Meeting Minutes: Ad hoc Storm Drainage Surcharge Committee of the Plumbing Board

Date: Oct. 31, 2023
Time: 1:00 p.m.
Minutes by: Lyndy Logan
Location: Minnesota Room, DLI, 443 Lafayette Rd. No., St. Paul, MN 55155

Plumbing Board Request for Interpretation

Division of Construction Codes and Licensing
REPORT ON PLUMBING PLANS

PLAN VIEW

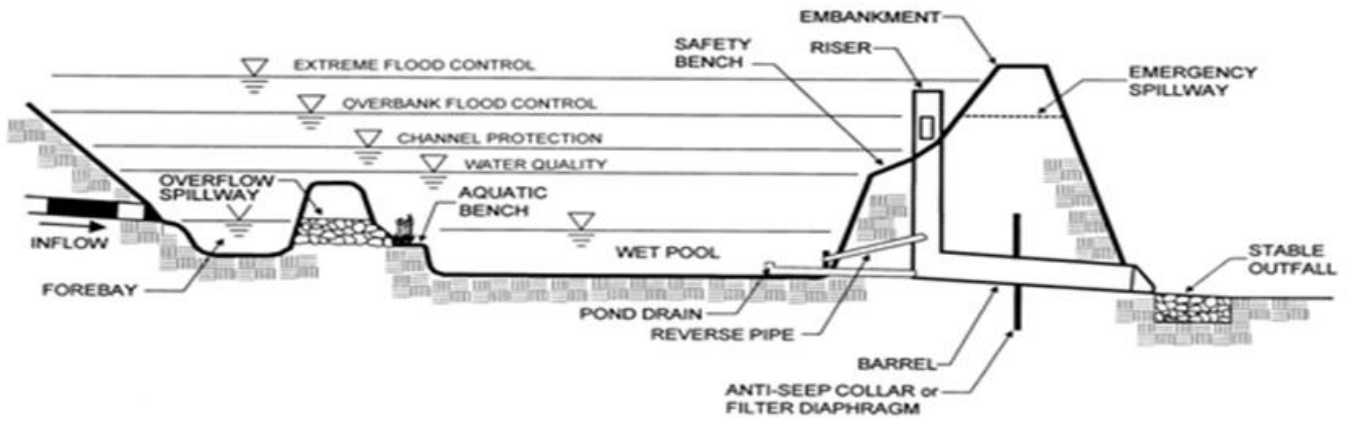
- Dimler referred to **Attachment C** showing MPCA's [stormwater ponds diagram](#).
- Dimler provided an overview of each of the elements of a stormwater pond shown in the MPCA's stormwater ponds diagram.

- Dimler directed the committee to the various water levels shown on the diagram, particularly the wet pool level and the water quality level.
- Dimler explained the wet pool level is the normal level of the pond when there isn't any inflow. He also noted that the water quality level is the level the pond achieves when it receives 1800 cubic feet of water per acre discharged to the pond plus 1" of rainfall over the affected area required by MPCA design requirements.

- Dimler explained the water quality level is designed to allow any sediment, nutrients and debris to settle out before being discharged from the pond.

- Dimler then explained the various pond features and how they correspond with the 2, 10 and 100 year rainfall events.
- Becker asked Dimler what percentage of storms would typically exceed the 10 year event. Dimler noted that around 10% of storms would be expected to exceed the 10 year event.

- WebEx chat message from Karen Kill: If the stormwater pond outlet is not being reviewed for surcharge because it is "part of the pond design," then why isn't the inlet also being considered part of the pond design? Forebays are required under Brown's Creek Watershed District rules.

- Matt Pavek – Noted that he would consider the upstream piping part of the ponding system because they typically use some form of treatment device prior to discharging into the pond.

A motion was made by Abrahamson, seconded by Wahlen, to recommend to the Board, to accept the invert of the sewer to discharge to the pond at the water quality level to reduce a 90% chance of surcharging the sewer, as it pertains to 31.5 and 309.1. The roll vote was unanimous with 5 votes in favor of the motion; the motion passed.
